Kitsap County Department of Community Development

Administrative Staff Report

Project Name: Creekside Housing Development - Major Revision-78 units

Type of Application: Administrative Conditional Use Permit

Site Plan Enlarged

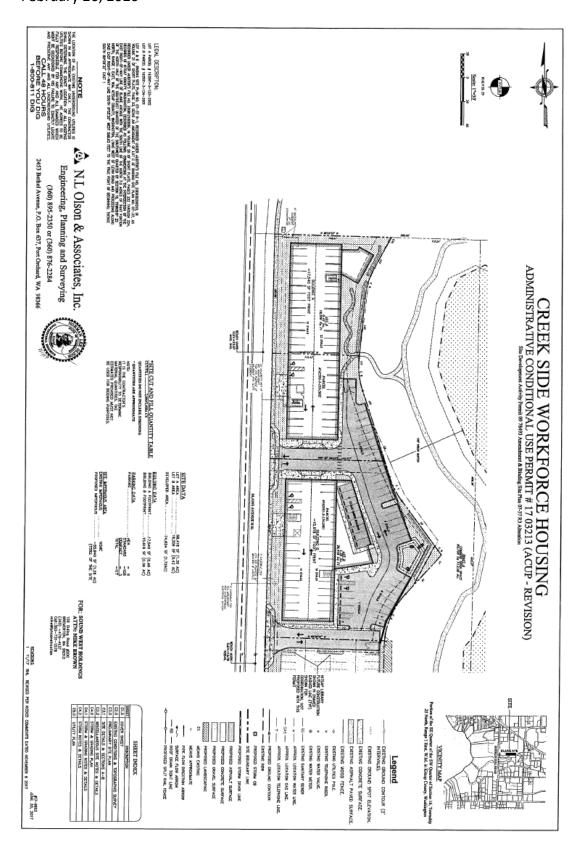
The Fire Marshal's office commented on the need to relocate FDCs/hydrants as indicated on plan and show PIVs or exterior accessed riser rooms on plan. All comments have been addressed.
